To: Bidders for the *Oak Brook Park District- Central Park Improvements*

SUBJECT: ADDENDUM NO. 1 TO THE BIDDING DOCUMENTS FOR:
Oak Brook Park District – Central Park Improvements
Bid Group #1 Bid Packages 1 - 19

Project No. 07-5646-04

QUESTIONS AND ANSWER LOG

SD4.08

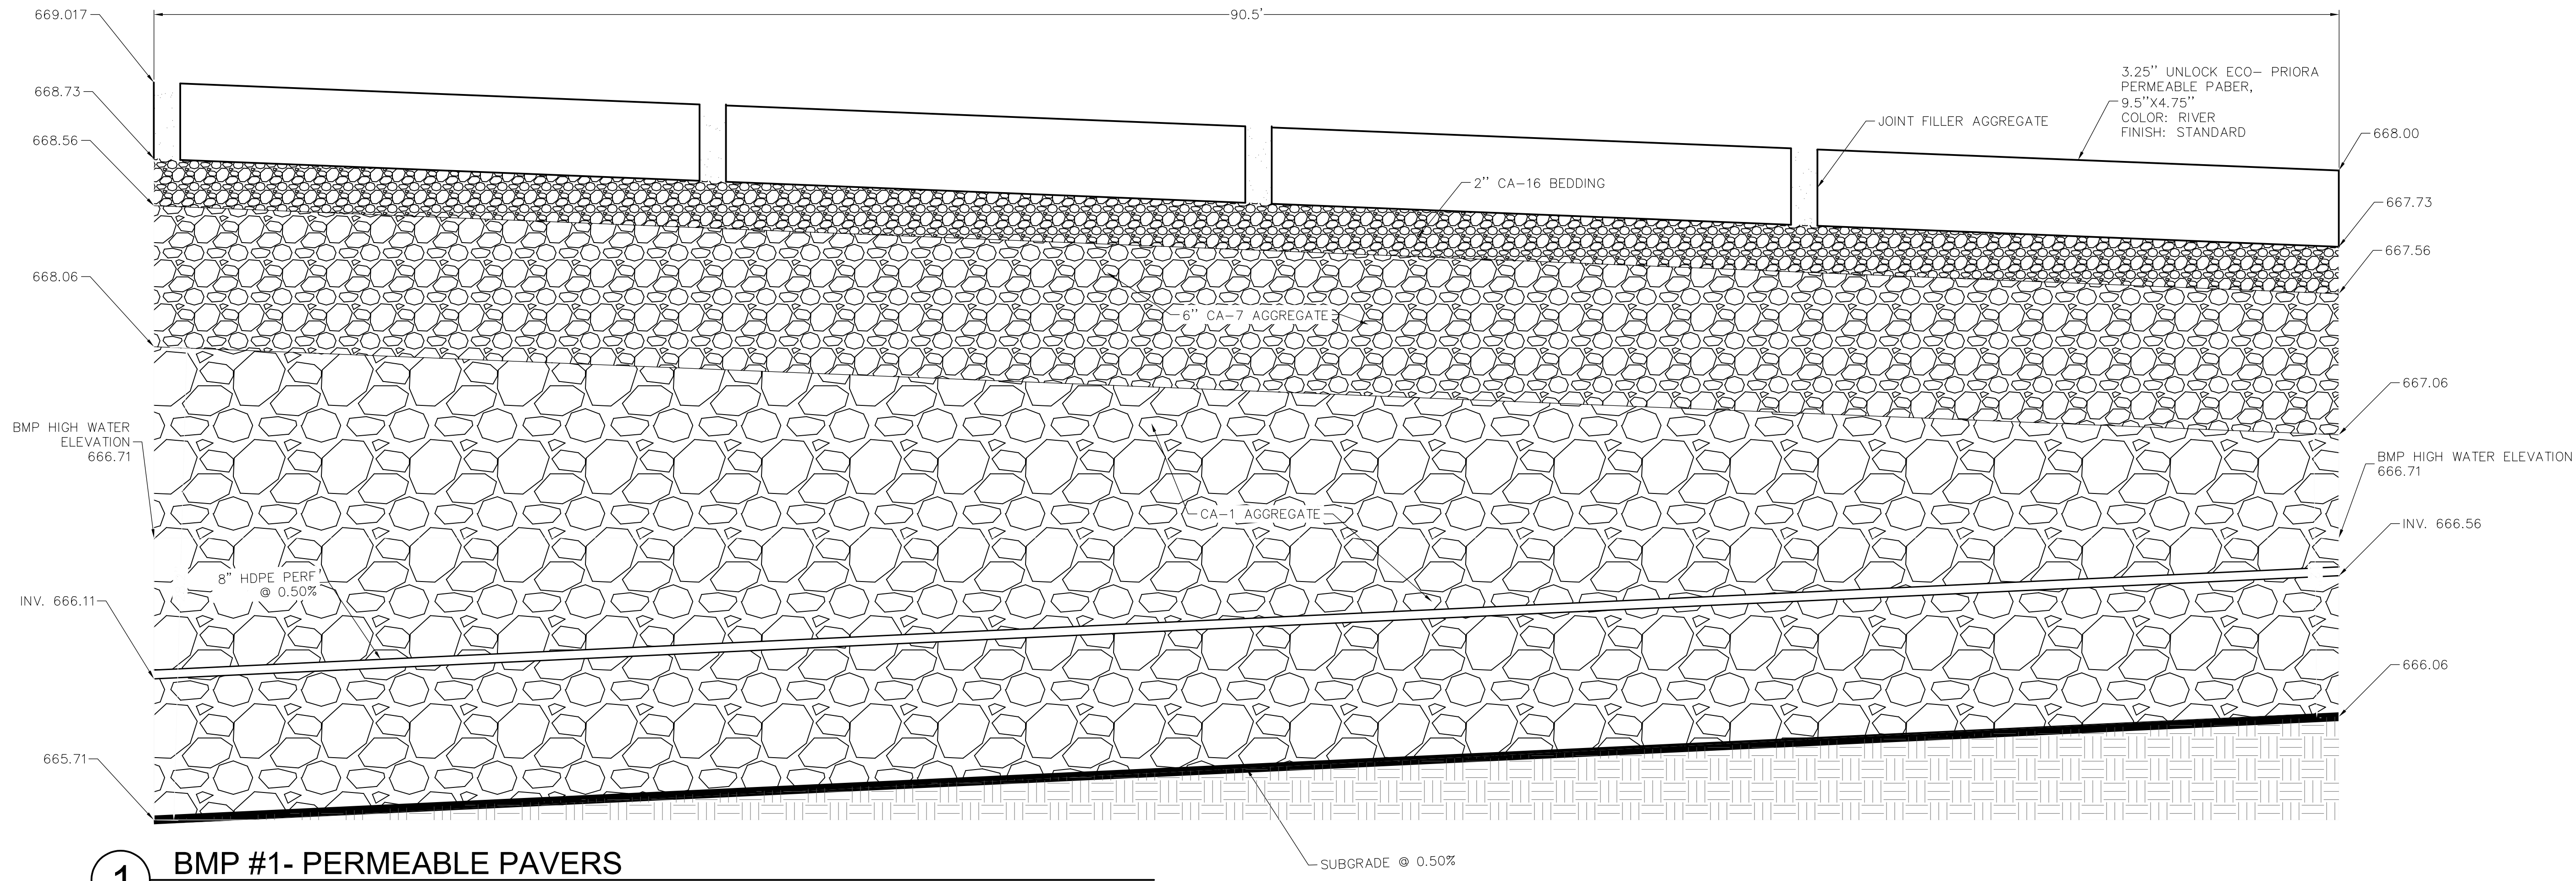
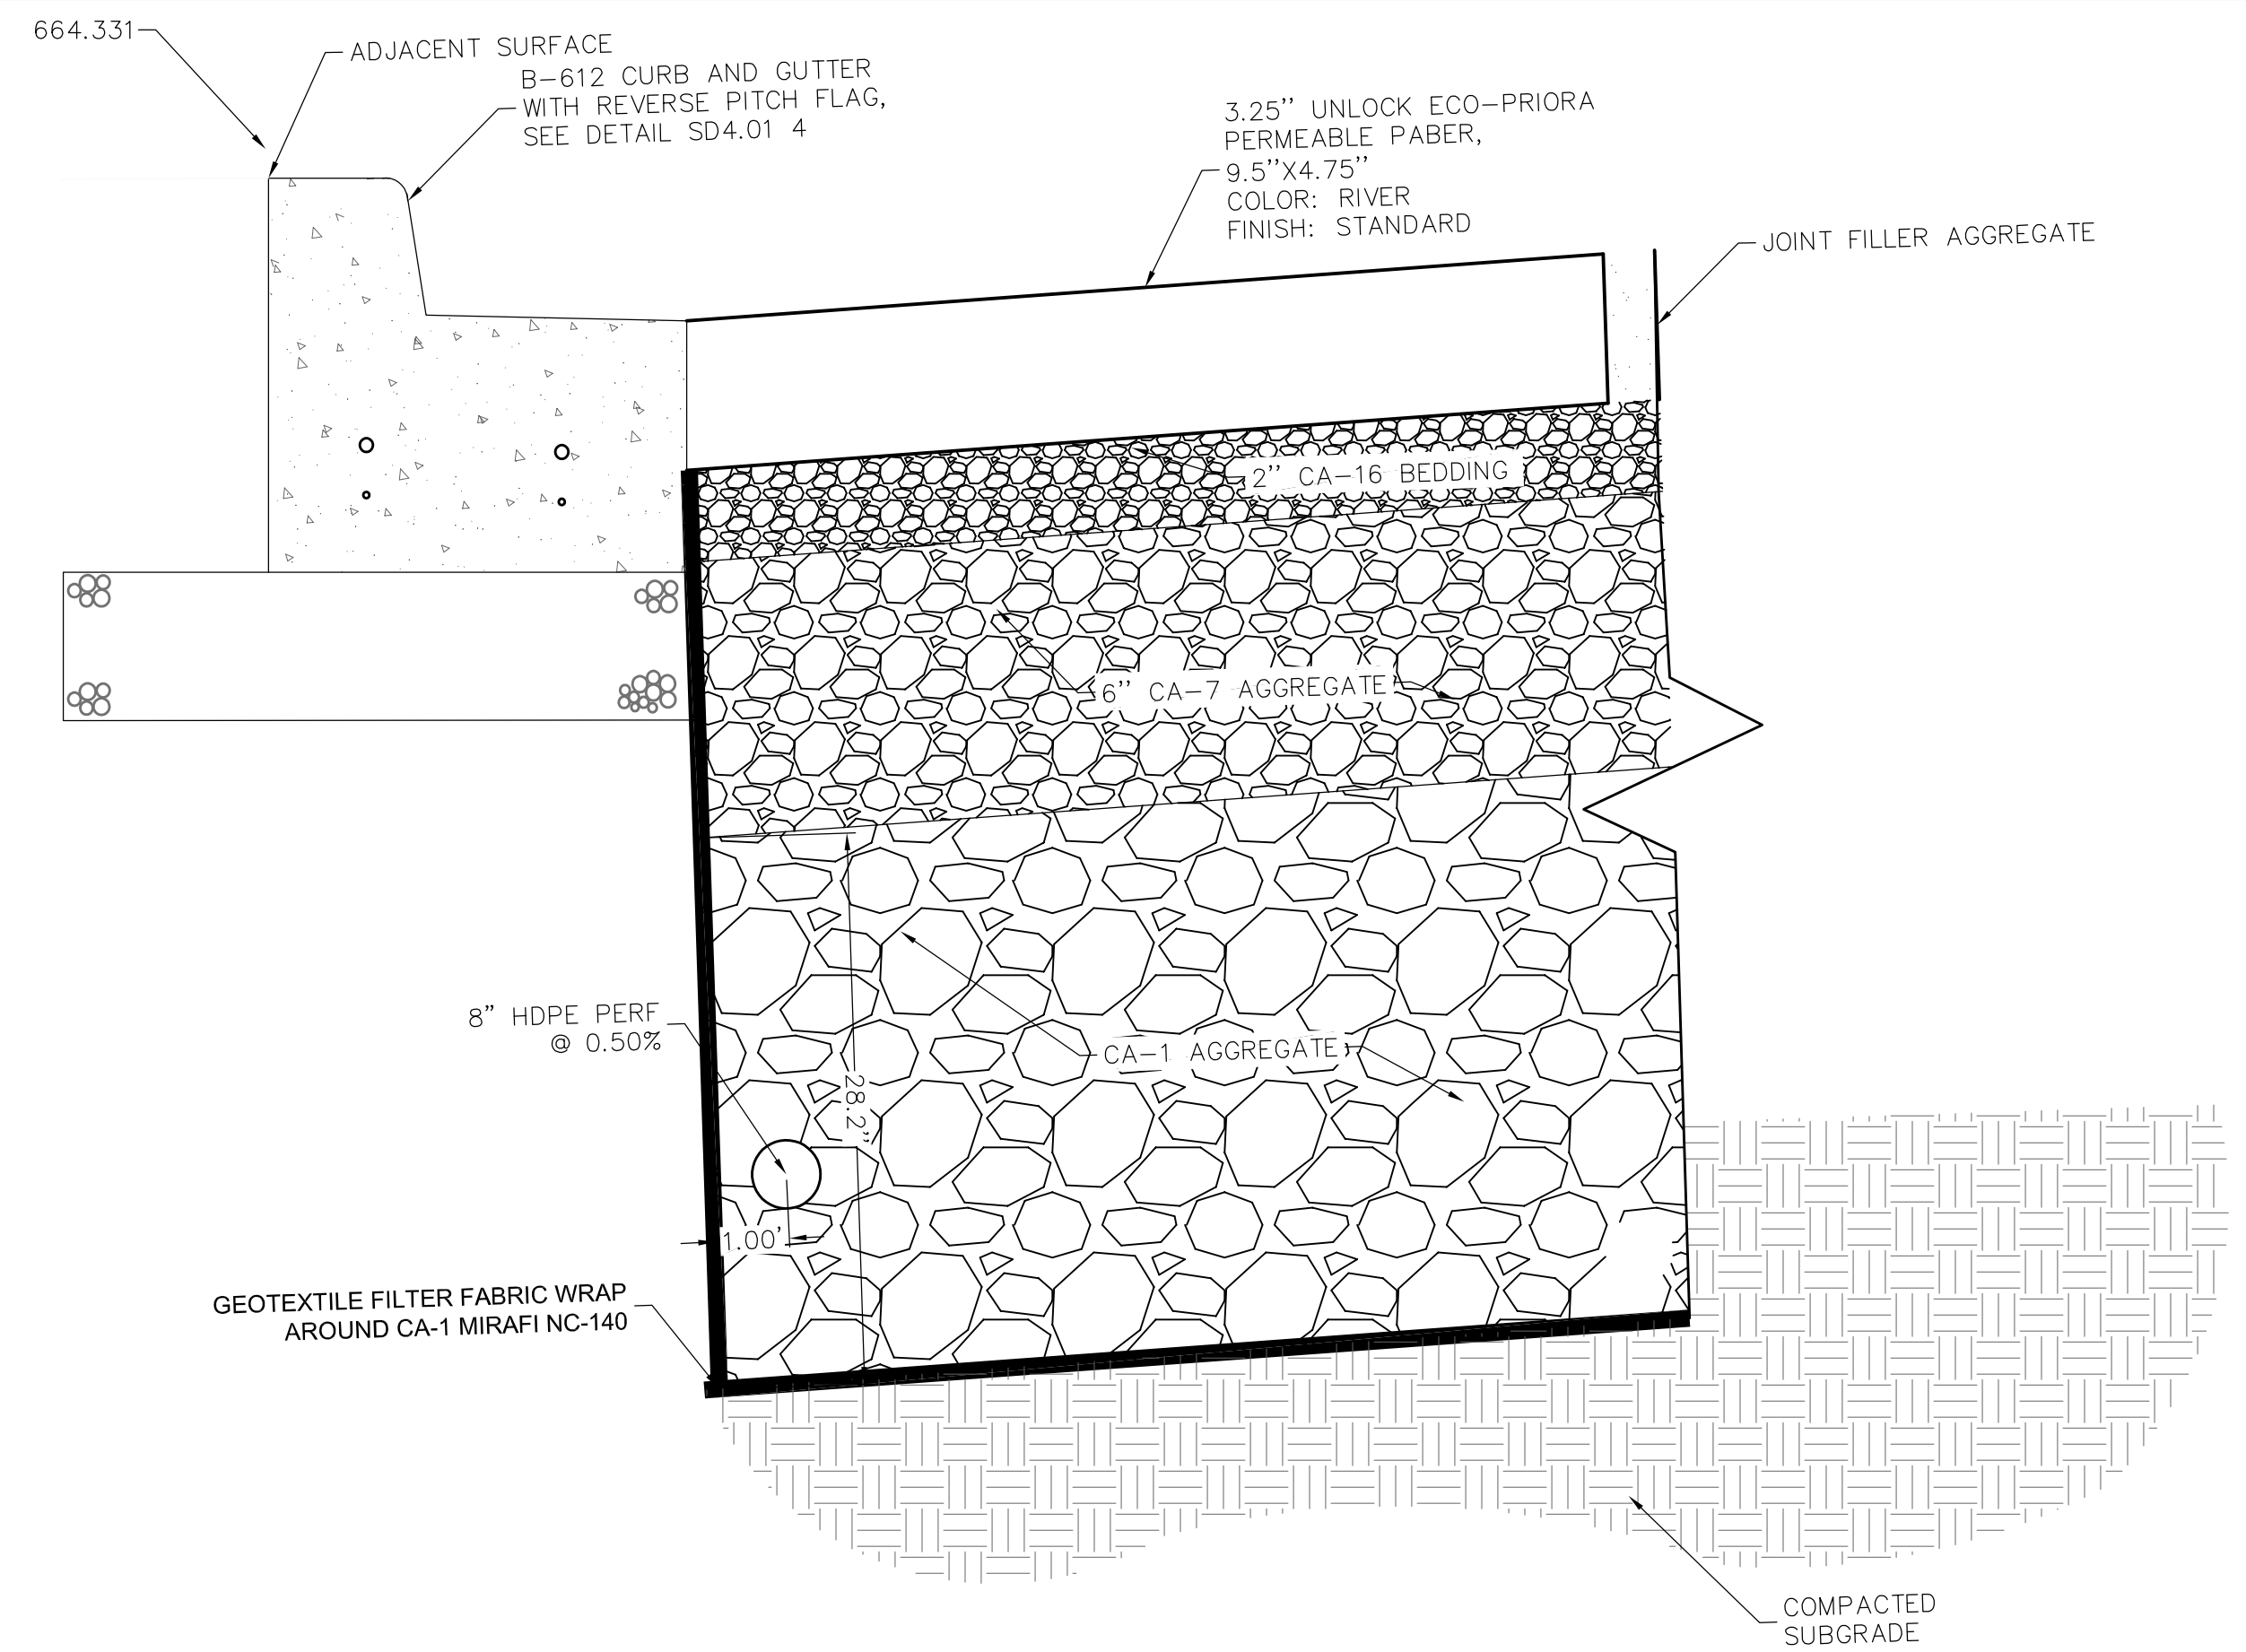
8. SD4.07 – Detail sheet added with wood enclosure and accessible curb ramp.
9. SD4.08 Detail Sheet added for specific Permeable Paver BMP #1 area located at the north parking lot. Contractor to slope subgrade as specified and verify BMP Volume required per County Code with as-built topo survey.
10. SD4.09 Detail Sheet added with the following details: 2' Inlet, 3' Catch Basin/Inlet, Curb Cut Detail and Nyloplast Drain Basin Detail.
